Addendum Review of Environmental Factors

Re-development of the Blayney Multipurpose Service Facility –
Addendum 1

20/12/2024

Figure 9: General Arrangement Plan showing the Proposed Amended site layout

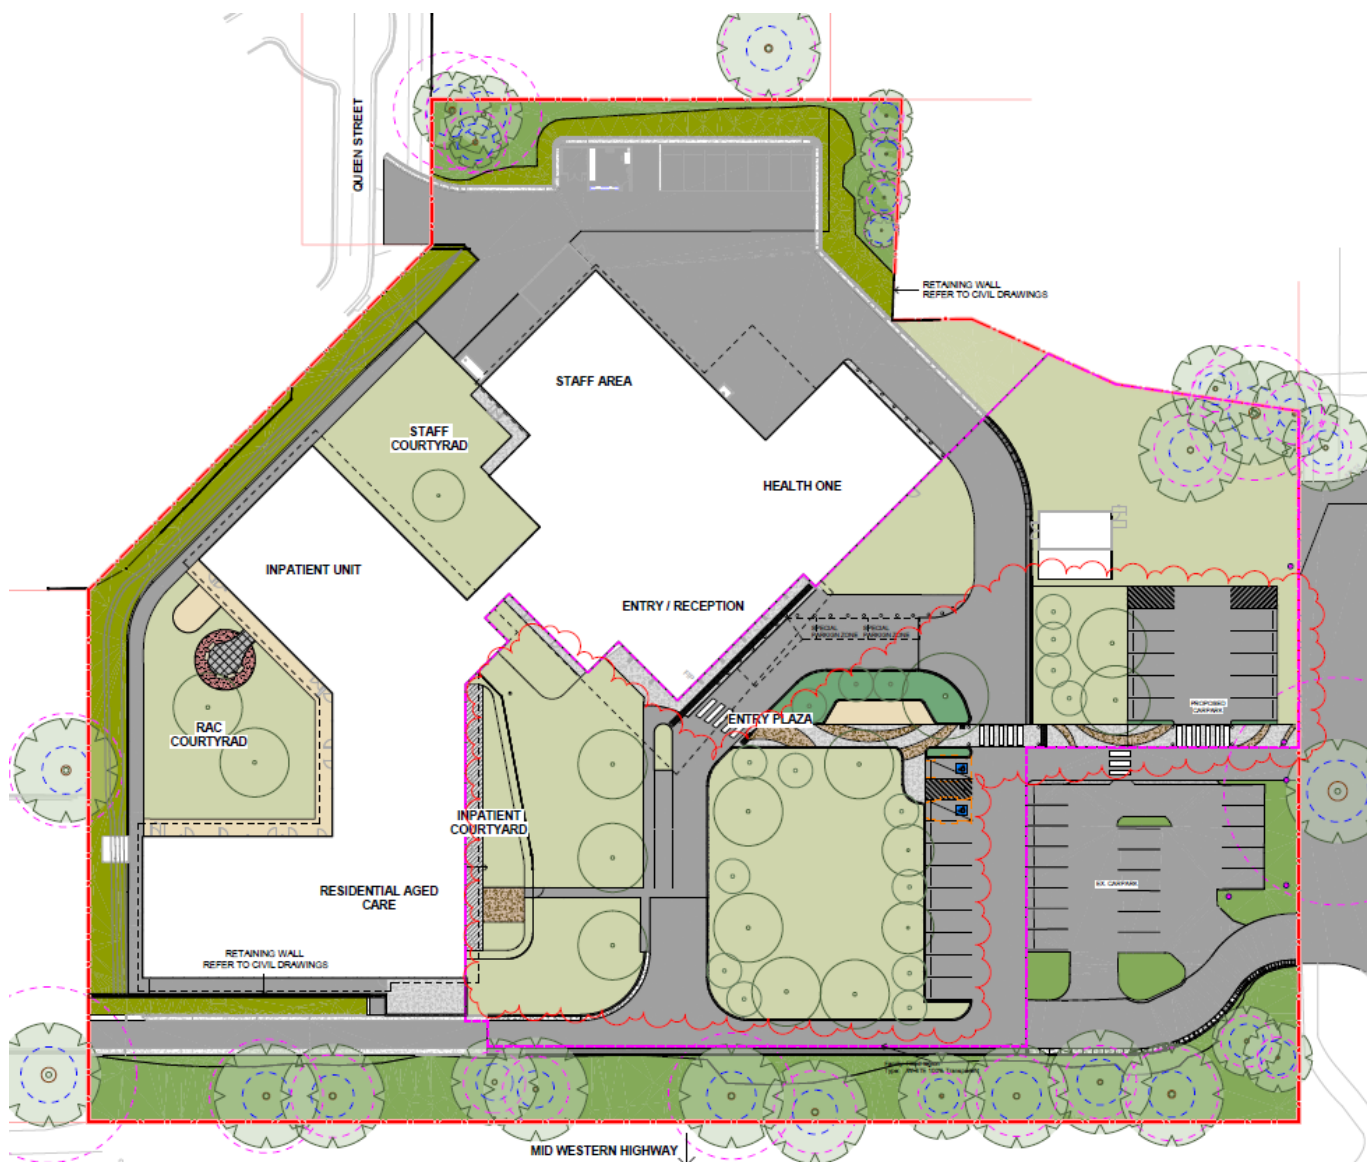
Since the approval of the Original REF, the design team further developed the proposal in response to flood mitigation and value engineering requirements, as described in **Section 1** of this document. Accordingly, this Addendum REF details the following proposed amendments to the Approved Proposal:

- New flood mitigation works;
- Revised civil design arrangements;
- Amendments to the tree management approach; and
- Amended landscape design.

Figure 10: Proposed swale – typical detail

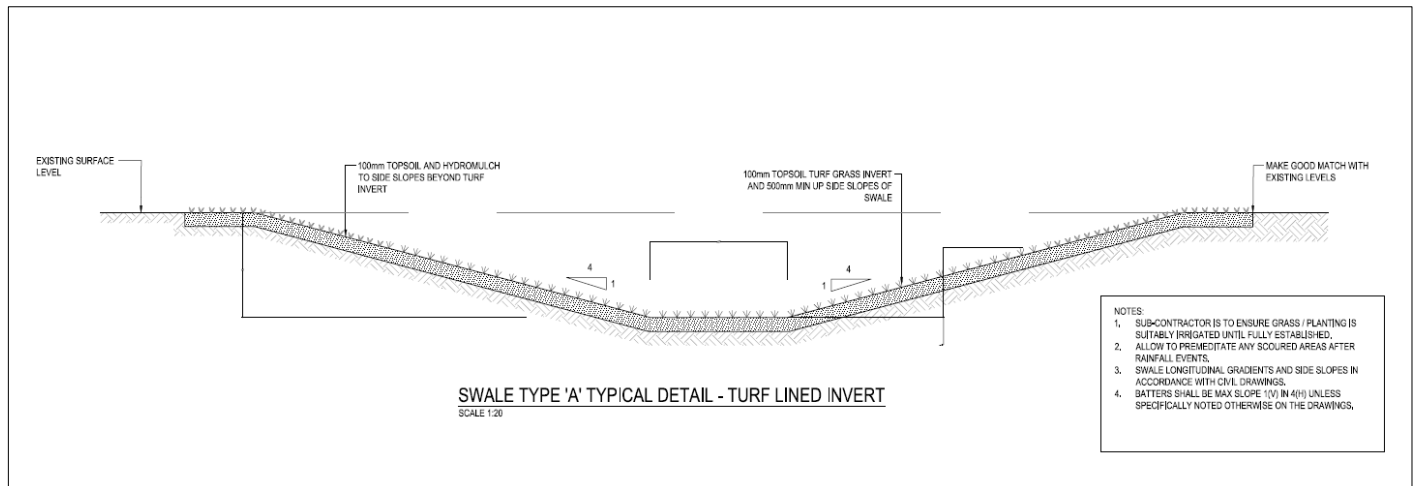
- construction of a perimeter table drain (swale) along the western boundary of the site to convey surface floodwater originating from Martha Street to the south and the adjacent Blayney Ambulance Station to the south-west, to Queen Street to the north. The swale would be turf lined and would typically be between 500mm and 700mm deep, and would range in width and grade, with the long-fall ranging between 1:90 and 1:75 at its steepest point – see the typical detail at **Figure 10** below. A final widening of the drain sag point providing for local ponding around a surcharge pit is proposed for the rare events when Council's downstream pit and pipe network are at capacity. In extreme events, this ponding would overtop and flow to the north. A location plan of the swale is provided at **Figure 11** following.

Figure 12: Extracts of Approved General Arrangements Plan - Stage 3 (left image) and Proposed Amended General Arrangements Plan – Stage 3 (right image)

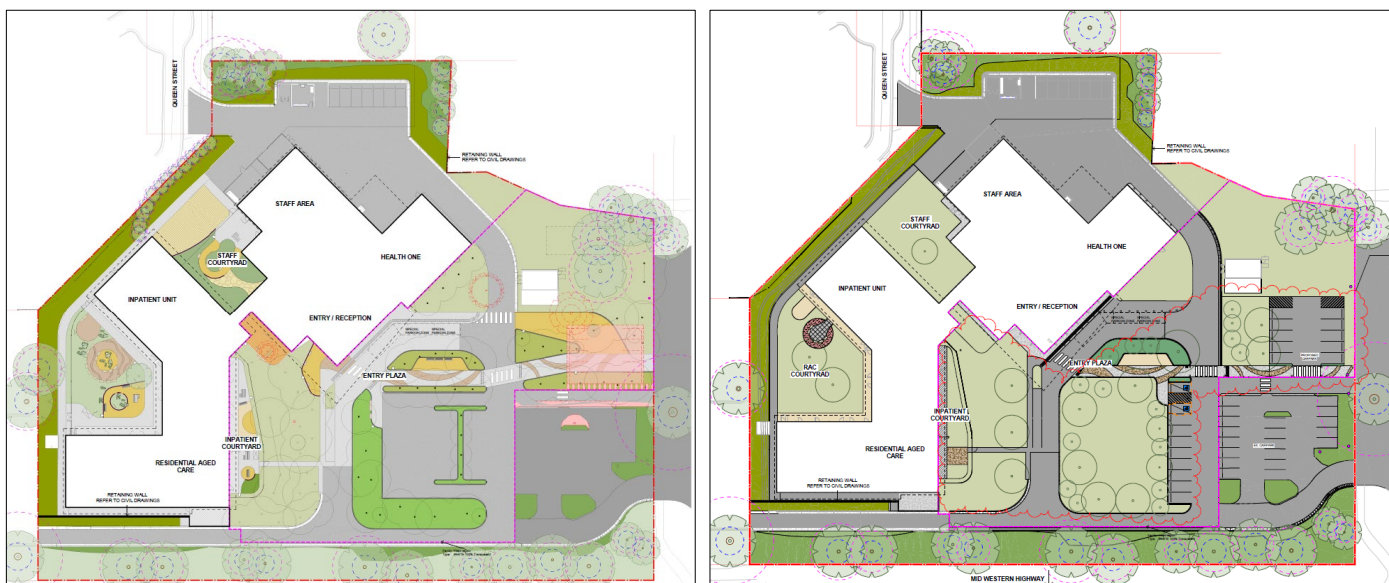
In response to the proposed flood mitigation works, and in response to value engineering requirements, the following changes to the civil design are proposed:

- deletion of the western section of the previously approved new central carpark (delete 14 spaces including 2 accessible spaces);
- expand the eastern section of the previously approved new central carpark (addition of 4 spaces including 2 accessible spaces);

Figure 14: Proposed Amended site plan showing location of carparks and pedestrian paths in the south-eastern section of the site (note – one additional accessible carpark in western carpark not visible under plan label – see the landscape documentation at **Appendix E** for further detail).

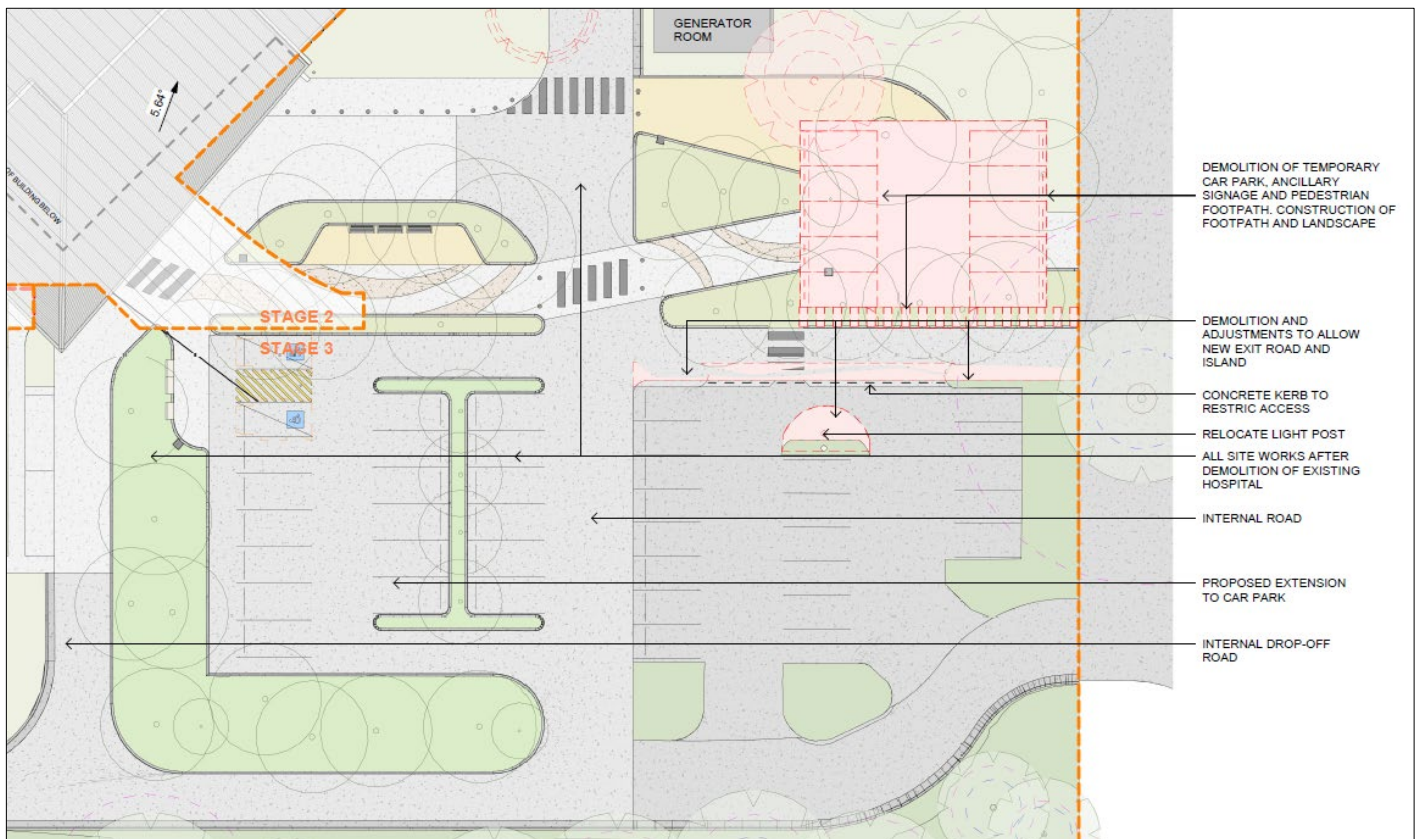
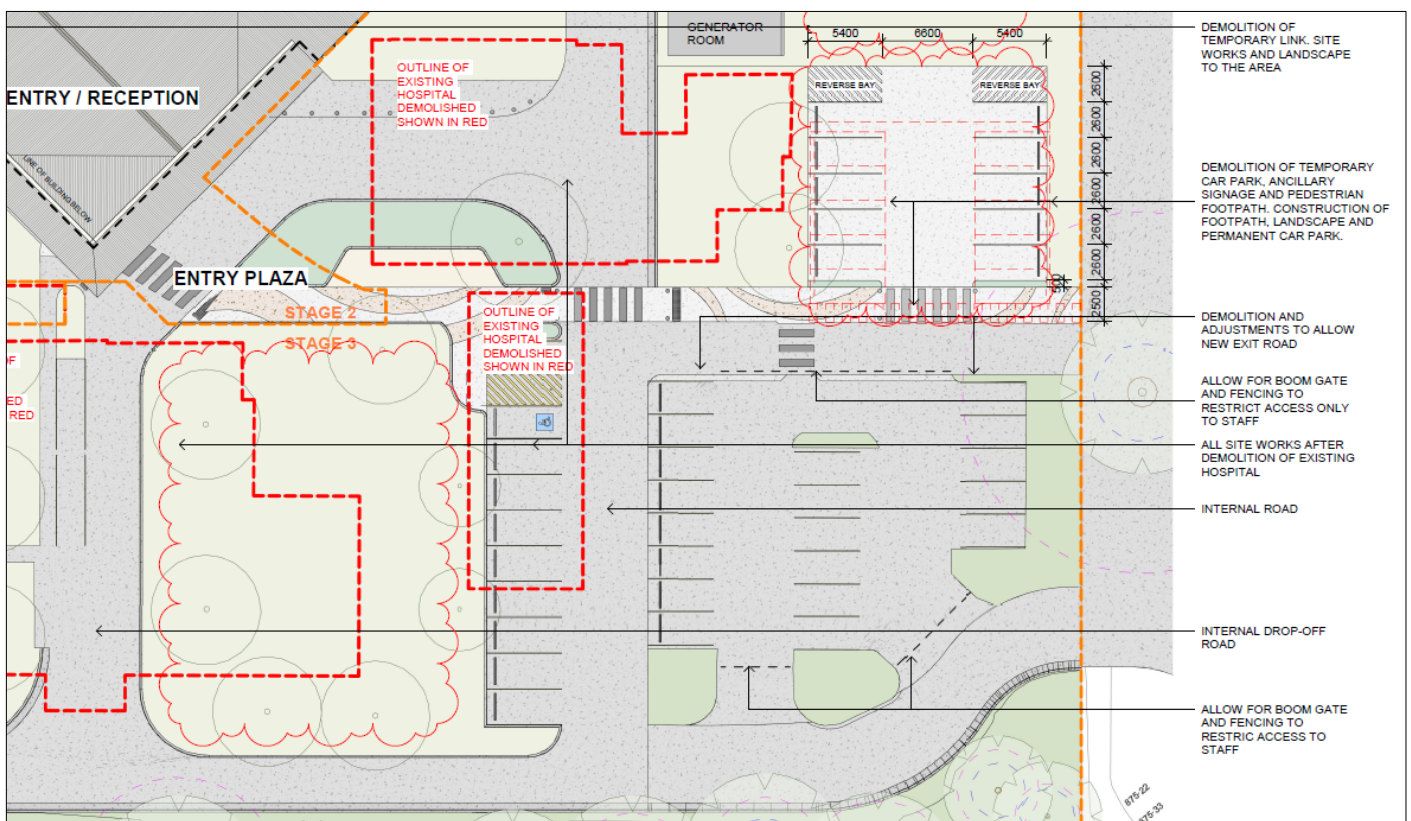
While the Amended Proposal involves the deletion of 2 previously-approved accessible carparking spaces, these are proposed to be replaced by 2 new accessible parking spaces. While these spaces are located slightly further away from the main MPS entry doors compared to the Approved Proposal (see **Figure 13** compared **Figure 14** in this Addendum REF) the spaces are still directly adjacent to a formed footpath which will provide a step-free accessible path of travel directly to the MPS entry.

Figure 16: Proposed Amended Cut and Fill Plan

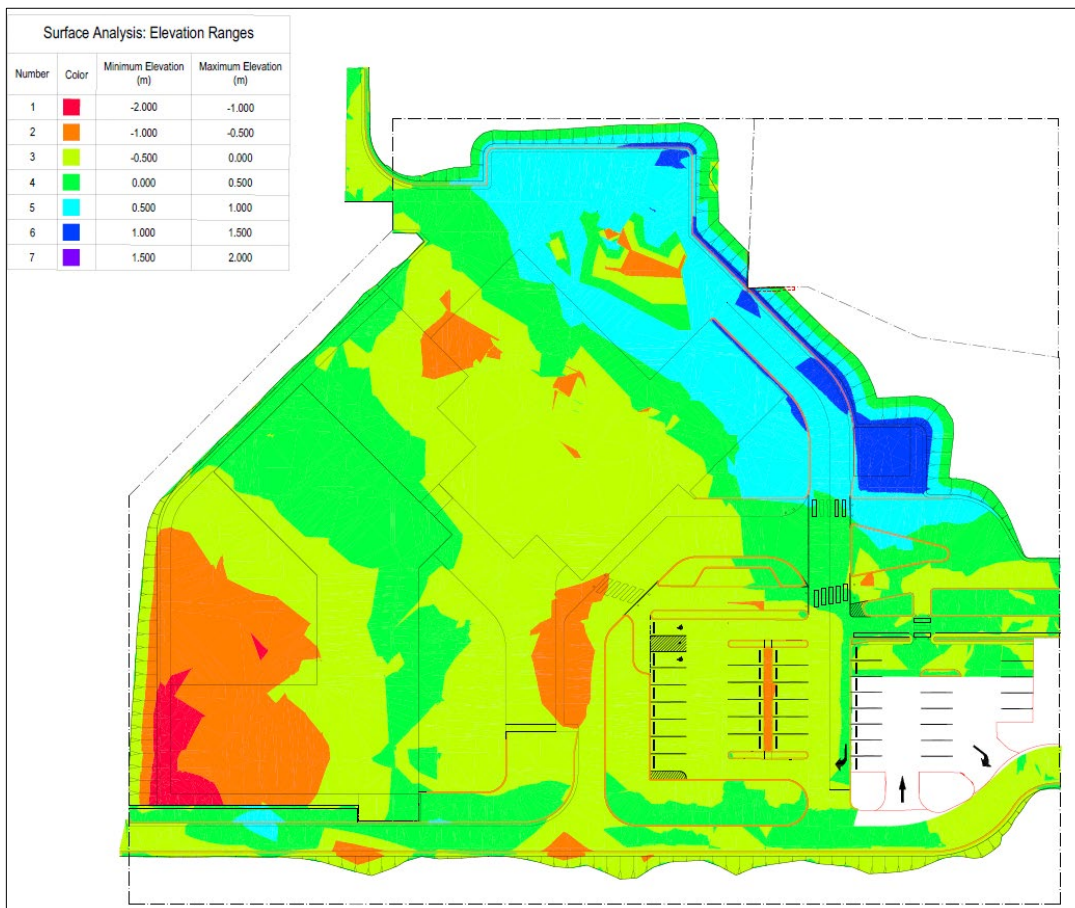
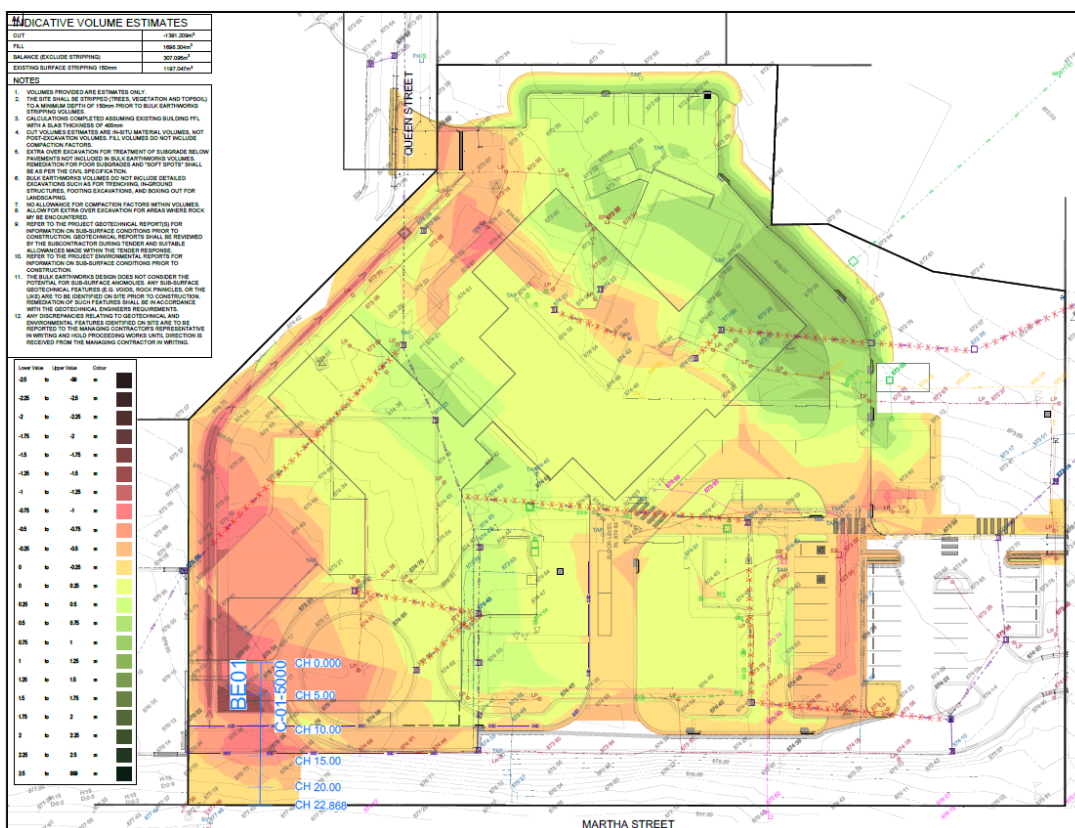
- amendment of the bulk cut and fill plan to reflect proposed changes, as indicated in **Figure 15** and **Figure 16** below. Note the Approved Proposal estimated a net cut volume of around 162m³ for the overall site, while the Amended Proposal estimates a net fill volume of 307.1m³; and

Figure 17: Proposed Amended Tree Management Plan – additional trees to be removed identified with red rectangles

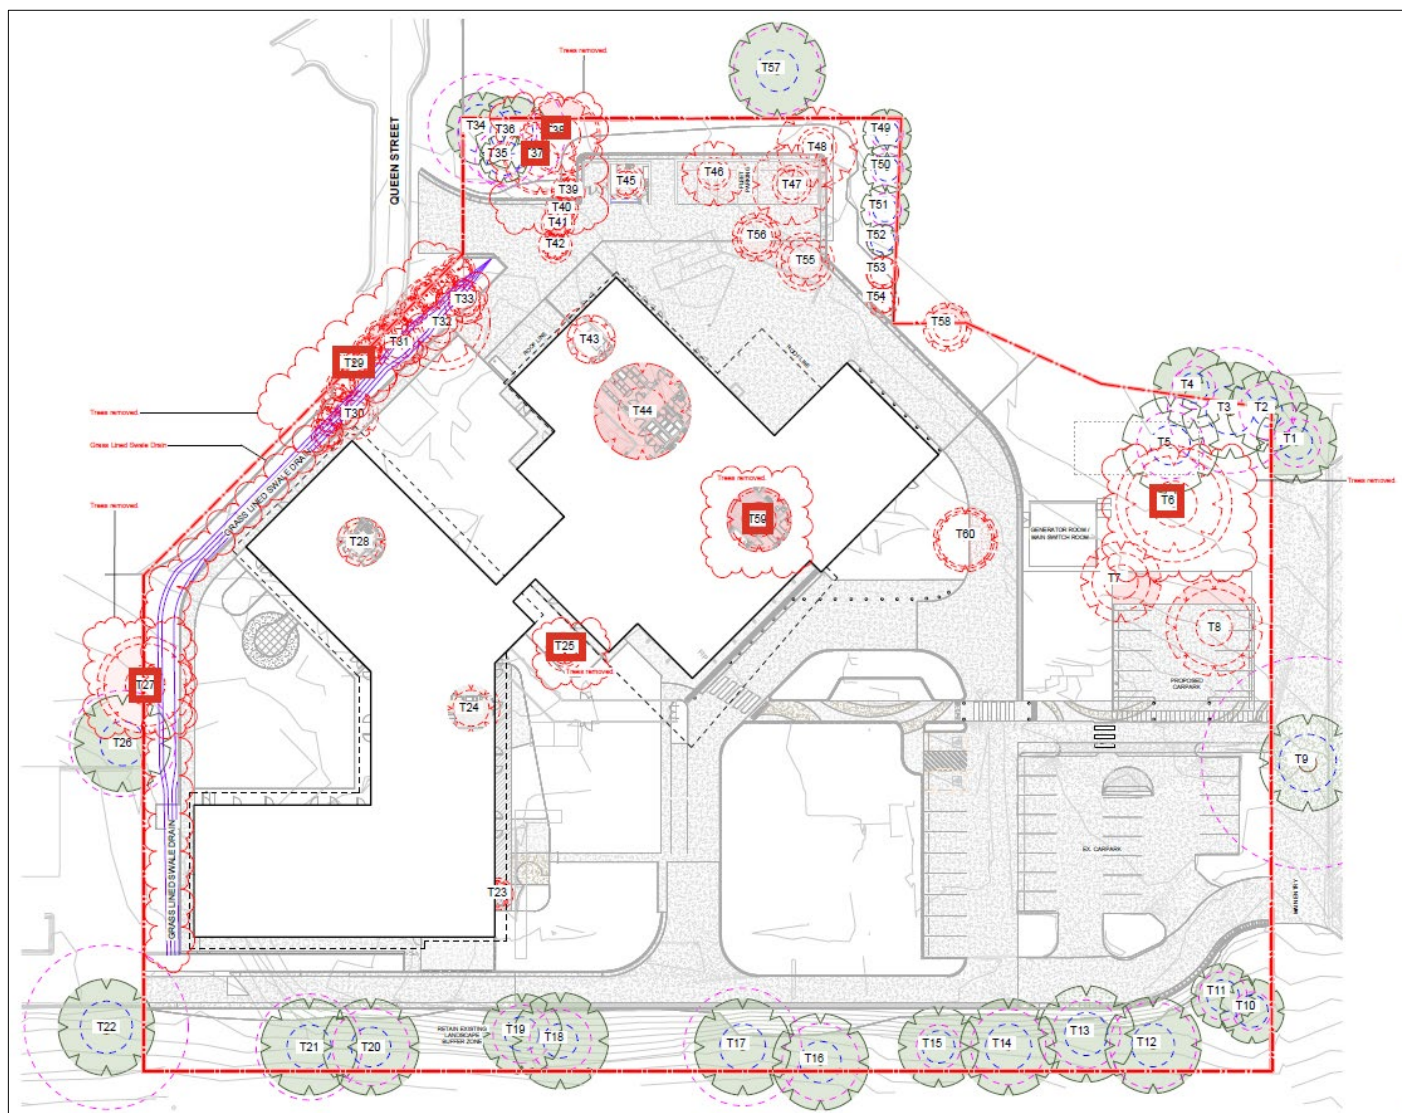
The proposed changes outlined above resulted in changes to the tree management approach presented within the Approved Proposal. As outlined in **Table 3** below, the Amended Proposal involves the removal of an additional 7 existing trees compared to the Approved Proposal. An extract of the amended Tree Management Plan is provided at **Figure 17** below, with the additional trees to be removed identified with red rectangles. A full copy of the proposed amended Tree Management Plan is provided within the *Amended Landscape Package* at **Appendix E**.

Specifically, the additional trees are proposed to be removed in response to major new encroachments into their Tree Protection Zones / Structural Root Zones as a result of the following:

- the detailed design of civil works such as paving and grading of carparks;
- the proposed addition of the drainage swale along the western boundary; and
- the logistical difficulties in achieving successful transplantation of a mature tree.

Figure 18: Extracts of Approved overall General Arrangements Landscaping Plan (left image) and Proposed Amended overall General Arrangements Landscaping Plan (right image)

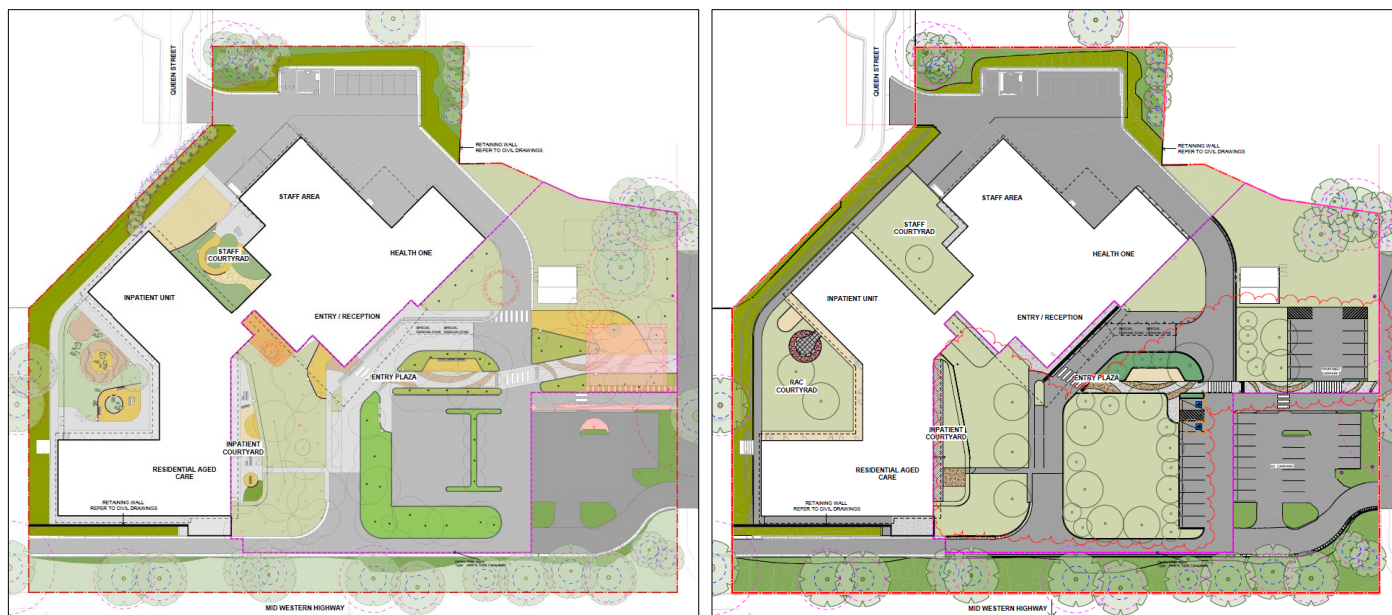
This Addendum REF is accompanied by an *Amended Landscape Package* – refer to **Appendix E**. The proposed landscaping changes are a result of proposed flood mitigation works, civil design changes and value engineering requirements. The proposed amended landscaping regime is compared to the approved landscaping regime within **Figure 18, Figure 19, Figure 20 and Figure 21** below.

- replacement of selected areas of soft-fall and hardscape / paving with turf;
- change in selected hardscape materials (e.g. replacement of abrasive concrete finish and pavers with coloured concrete);
- removal of selected landscape features (e.g. feature boulders, sandstone blocks);
- removal of selected outdoor furniture (e.g. seating);
- changes to landscaping design in response to amended carpark locations, as described above (e.g. replacement of previously approved new carparking area with turf and trees); and
- changes to selected plant selection details (e.g. pot sizes, plant spacing).
